MHTN
ARCHITECTS

Addendum No. 01

Project Name: Canyon Crest Elementary STEM Lab

Addendum No. 01 to the Construction Contract for the above referenced project:

M1.1 Sheet M101: Replace with new. See attached.

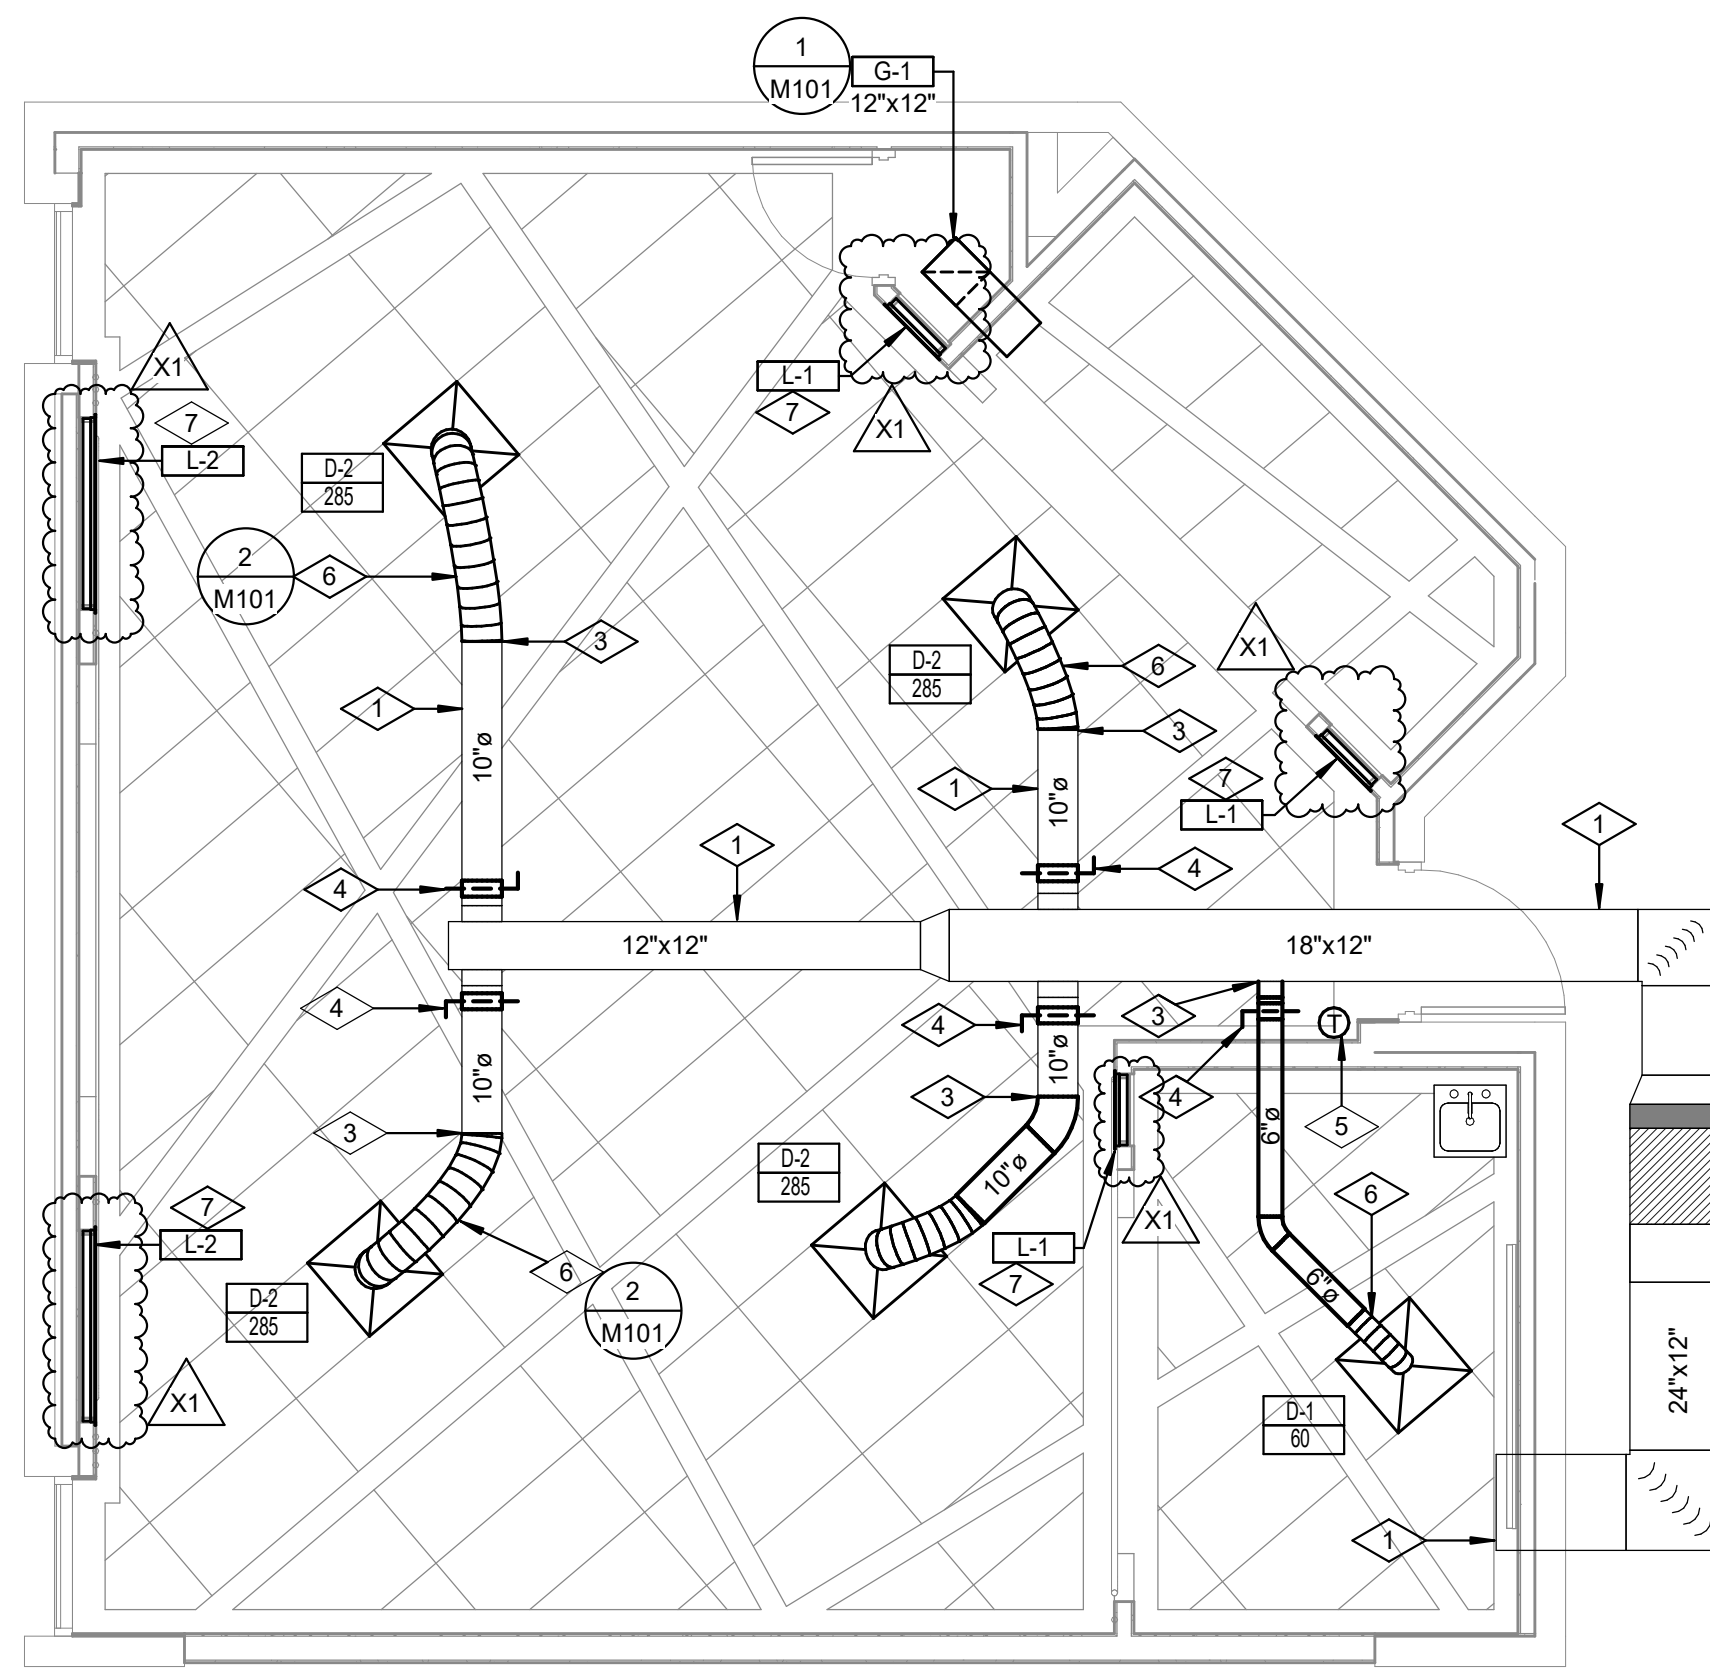
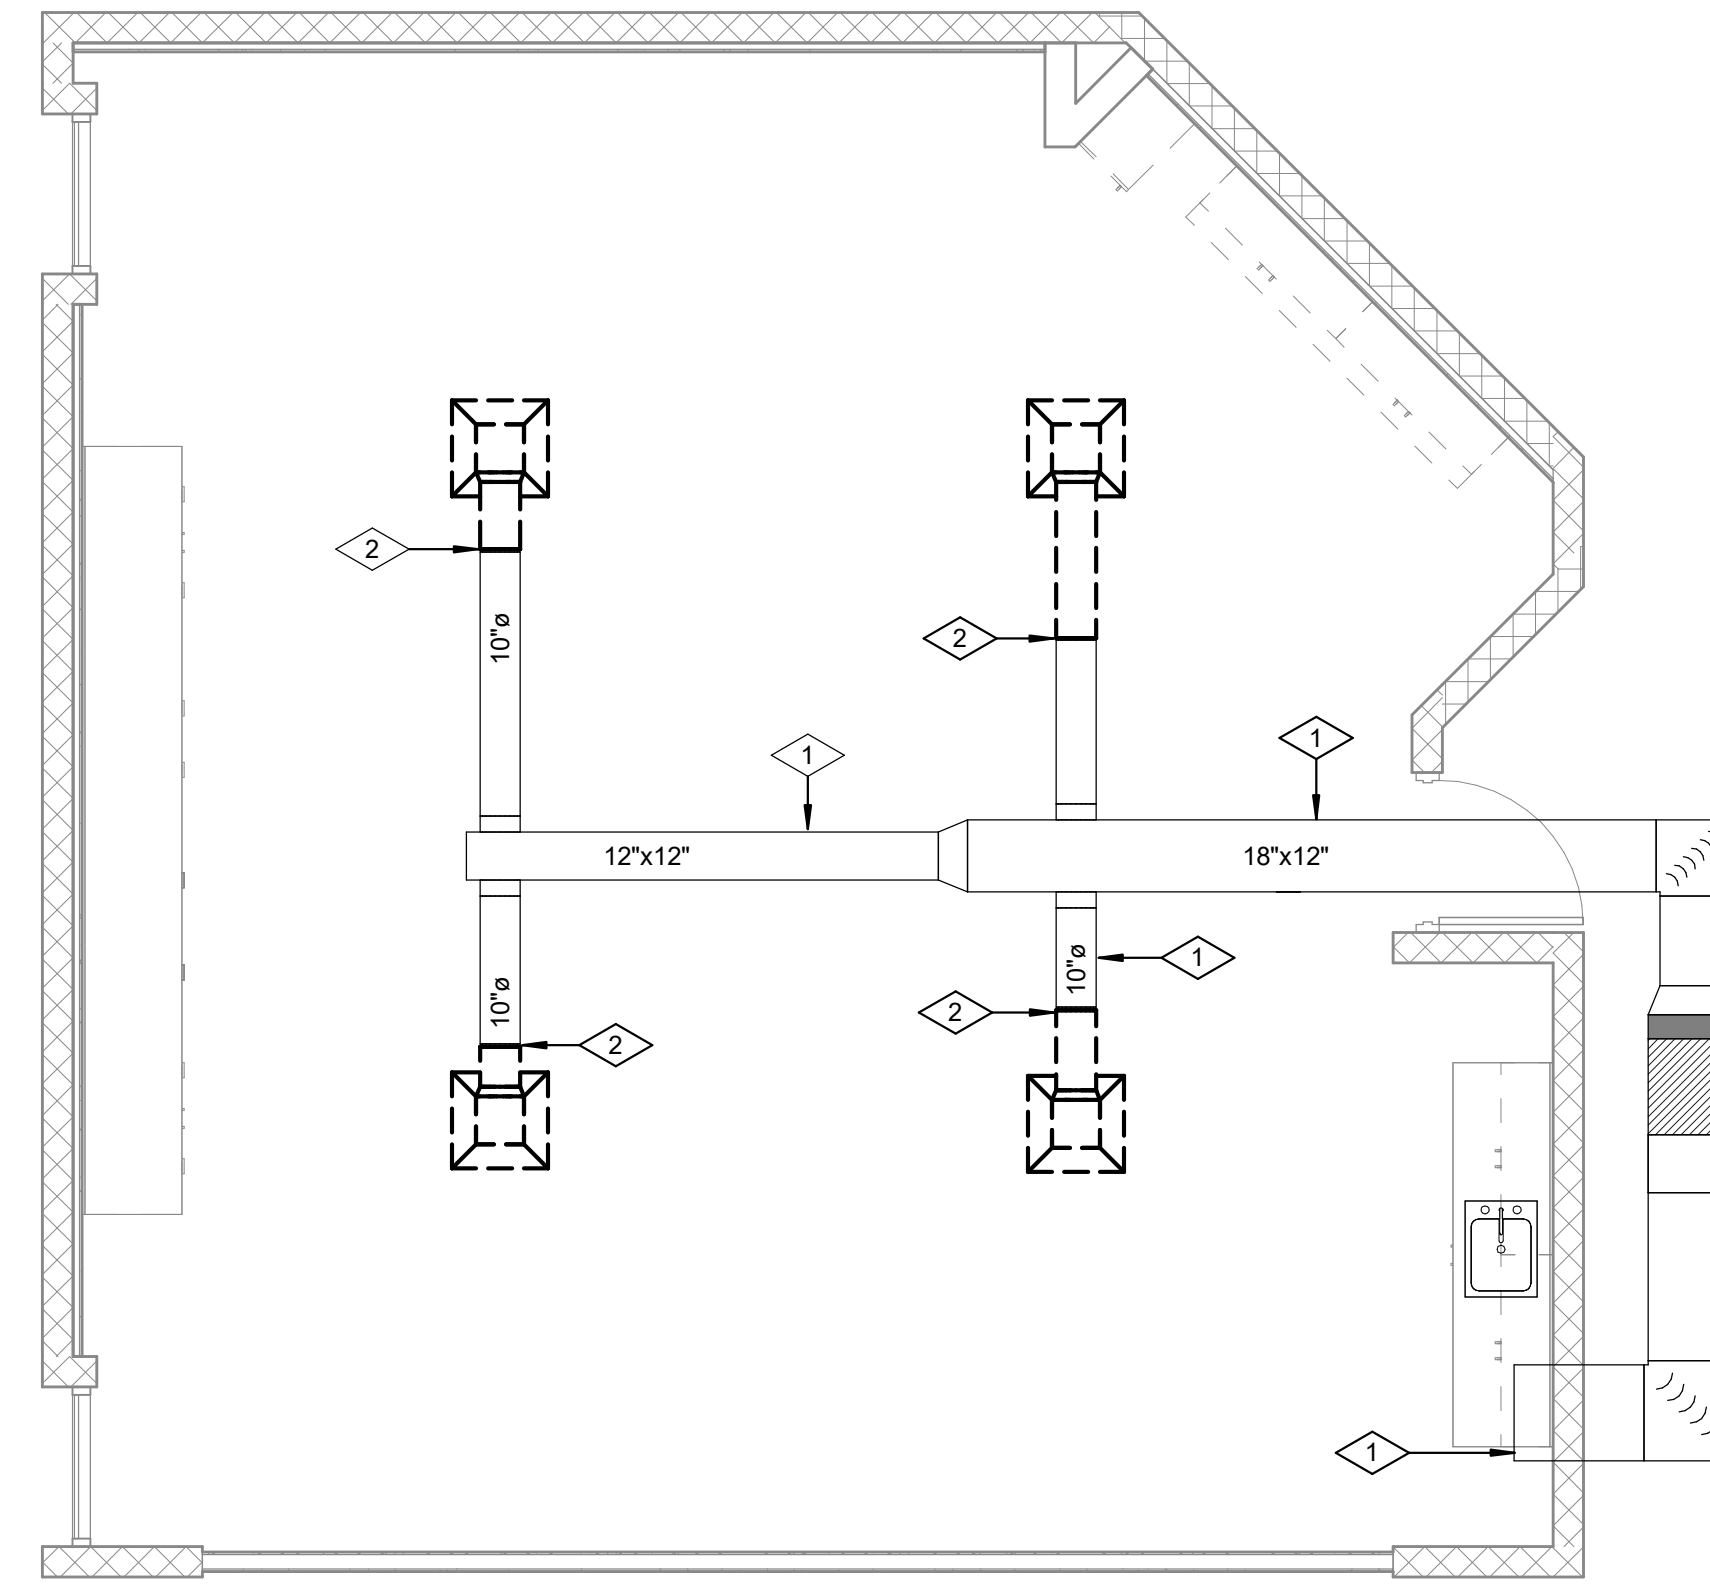
1. Add 5 decorative louvers as shown and sized per schedule.
